Attachment 2
Marked-up Pages

RBS USAR

FIGURE 6.2-61a
PRESSURE IN SHIELD BUILDING
ANNULUS VS TIME
RIVER BEND STATION
UPDATED SAFETY ANALYSIS REPORT

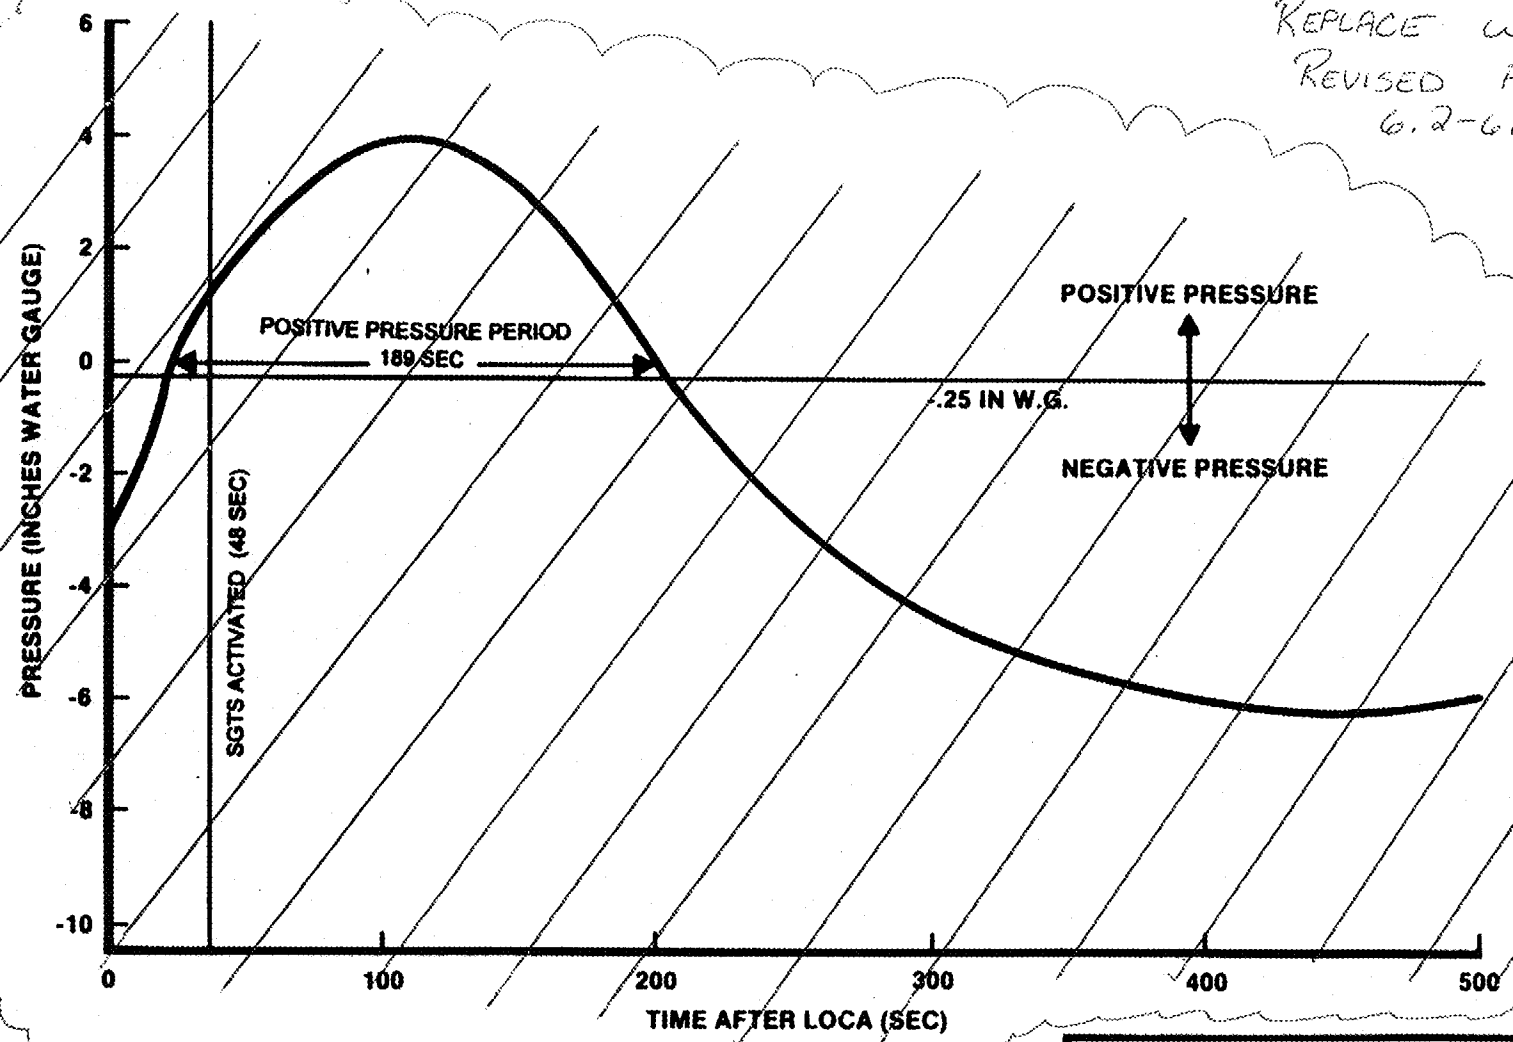
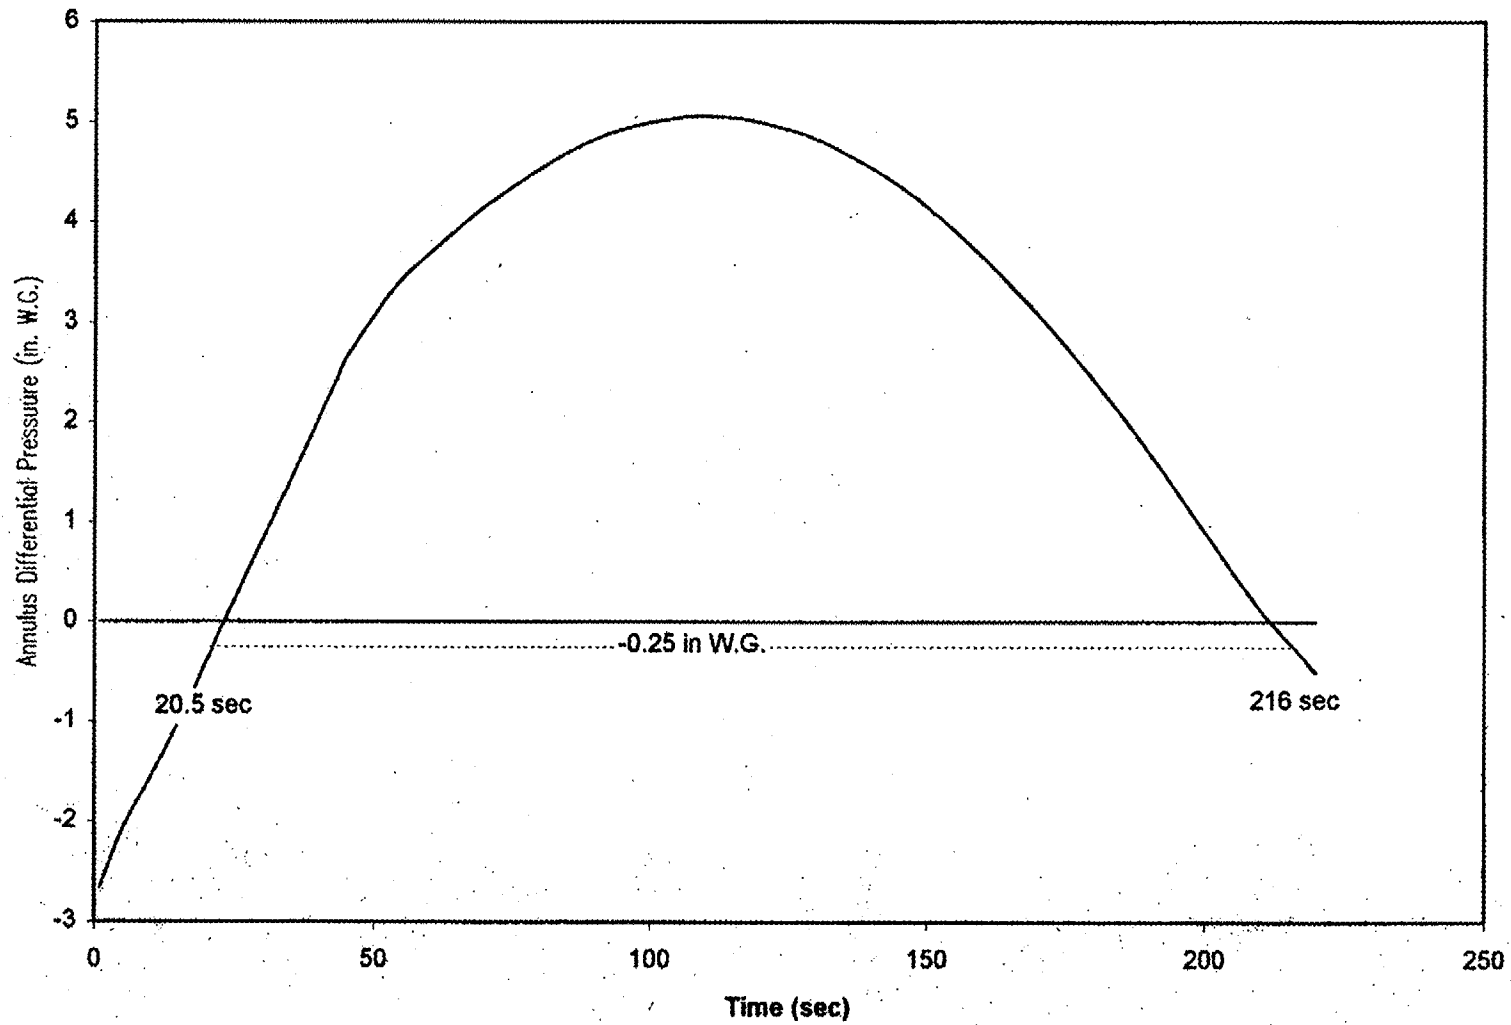
Fig. 6.2-61a indicates that there is a period following a LOCA during which a gauge pressure greater than -0.25 in W.G. exists in the annulus. This period begins approximately 24 sec after the LOCA and lasts for approximately 199 sec. The dose rate analysis during this period indicates that release of contaminated air from the secondary containment is within the limits of 10CFR100.

REPLACE WITH
REVISED FIGURE
6.2-61a

20.5

195.5

However, the offsite dose analysis uses the bounding value of 216 sec for the annulus (see Section 15.6.5).

REVISED FIGURE 6.2-C19
